# Deluxe Fashions Ltd

178/179 Baizid Bostami Road, Nazirabad Area, Chittagong  
(22.39048N, 91.81110E)

18 March 2014

# Observations

2<sup>th</sup> Floor Storage Area

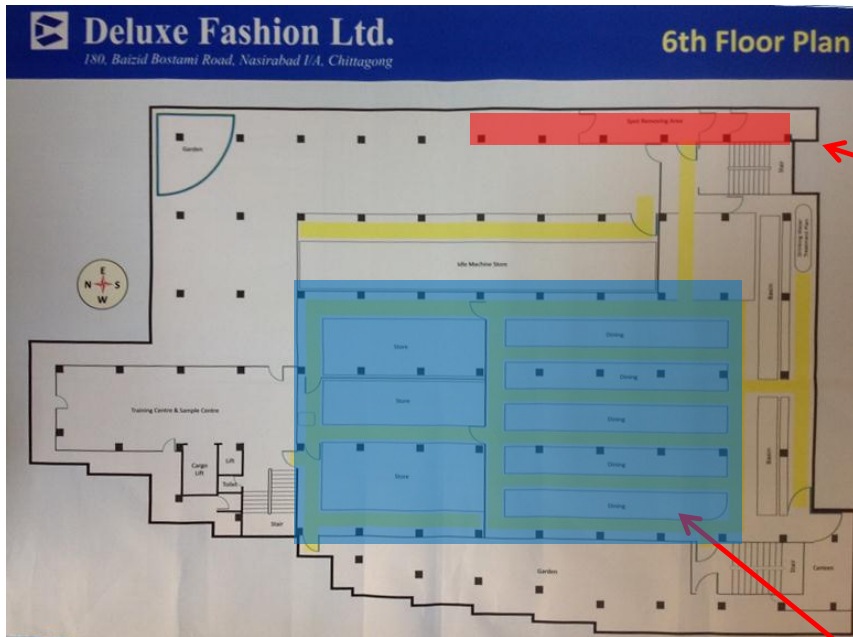
**Building Engineer to prepare controlled loading plans for all floors which will designate where storage can be placed.**

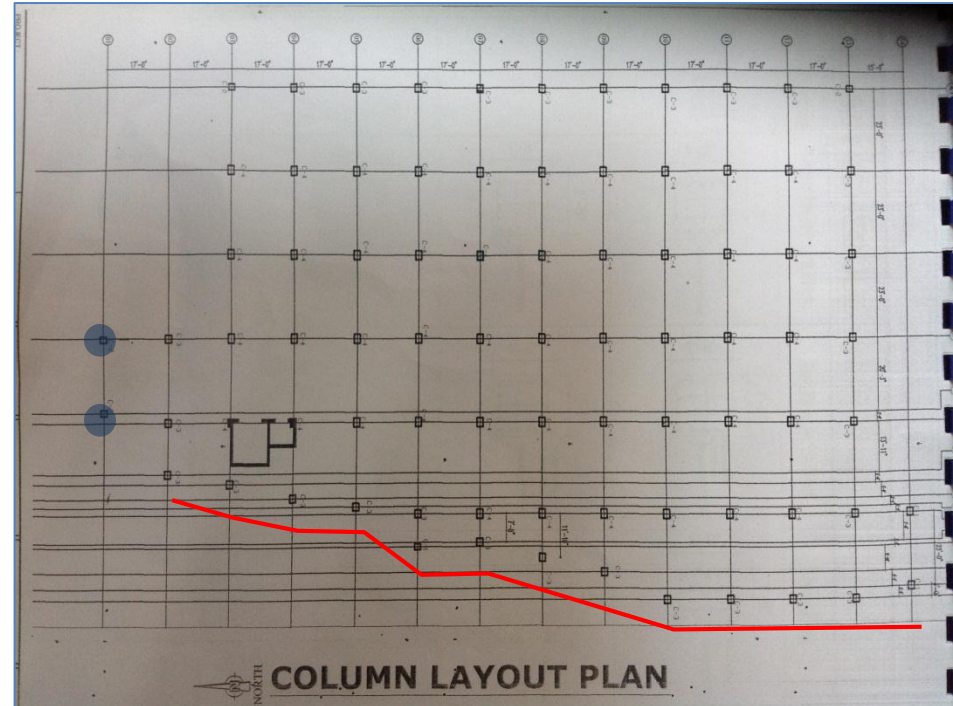
Mezzanine support column applies point load to Ground Floor suspended slab – which also supports heavy storage loads. Building Engineer to review design of ground floor slab.

Mezzanine structure not shown on structural drawings.

Steel structure at roof level not shown on structural drawings.

Building Engineer to survey as-built structure and update drawings including verification of steel structure at roof level and mezzanine level.
